# The Development of Grid Connection Infrastructure for the Zonnequa Wind Farm, Northern Cape Province.

Motivation for amendment of Environmental **Authorisation**

DFFE Ref.: 14/12/16/3/3/1/2033/AM2

July 2021

Figure 2.2: Layout map showing the authorised and proposed amended grid connection corridors for the Zonnequa Wind Farm

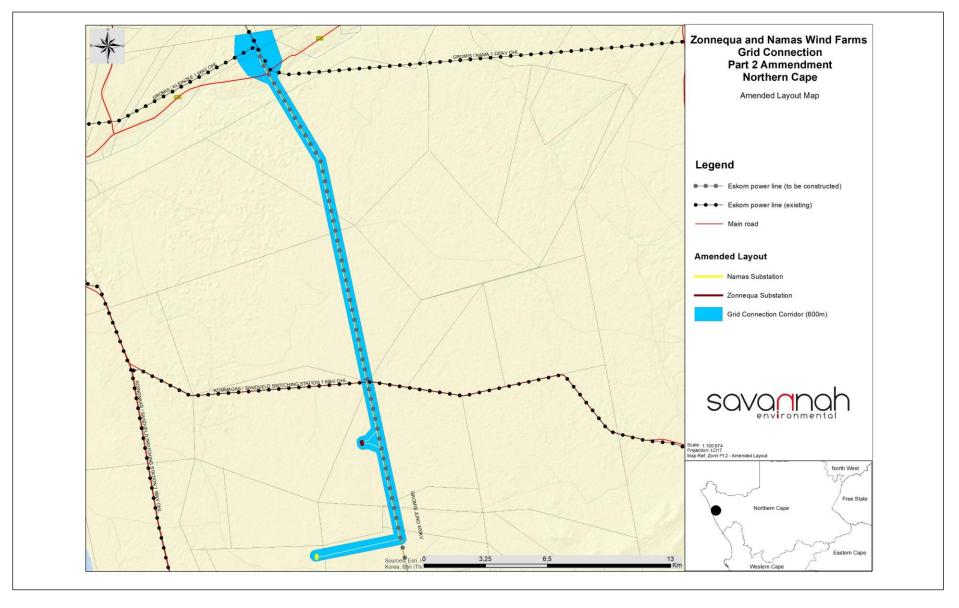
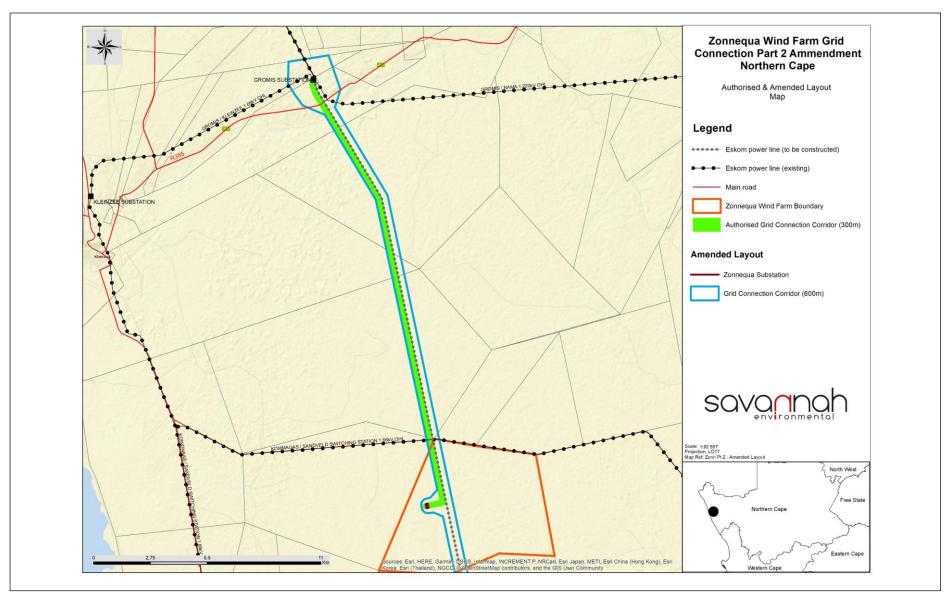
## It is requested that the corridor coordinates specified on page 4 of the Environmental Authorisation be amended from:

#### **CORRIDOR COORDINATES (600M):**

Latitude (S)	Longitude (E)
Starting Point (Strandveld Collector Substation)	29°47'6.06"S	17°14'10.83"E
Bend Point 1	29°47'0.66"S	17°14'22.96"E
Bend Point 2	29°46'44.83"S	17°14'38.91"E
Bend Point 3	29°39'6.89"S	17°12'50.06"E
End Point (Gromis MTS)	29°35'59.59"S	17°10'45.65"E

A double-circuit 132kV power line (known as the Strandveld-Gromis 132kV double-circuit power line, to be constructed within a 600m wide corridor

**Figure 5.1:** The revised sensitivity map for the Zonnequa Grid Corridor, illustrating the amended 600m wide corridor and realigned Strandveld Substation position.

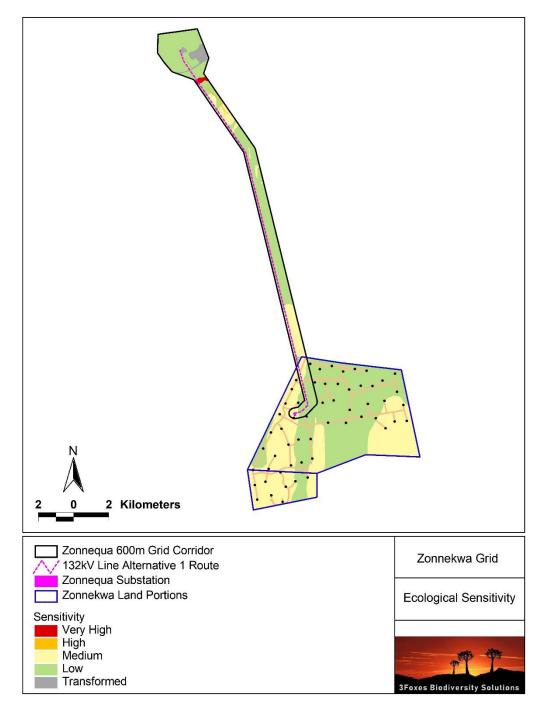
width and substation location. No new or additional sensitive features are within the amended grid corridor and substation location that were not present within the original corridor. As such, the amendment does not result in an overall increase in the impacts as assessed previously.

The amended layout of the Zonnequa grid connection infrastructure is located in similar areas to the original footprint and there are no High or Very High sensitivity areas (refer to **Figure 5.1**) which cannot be avoided, which is in-line with the recommendations of the original BA study. As such, there are no additional changes to the mitigation and avoidance measures that were recommended and in the grid BA study.
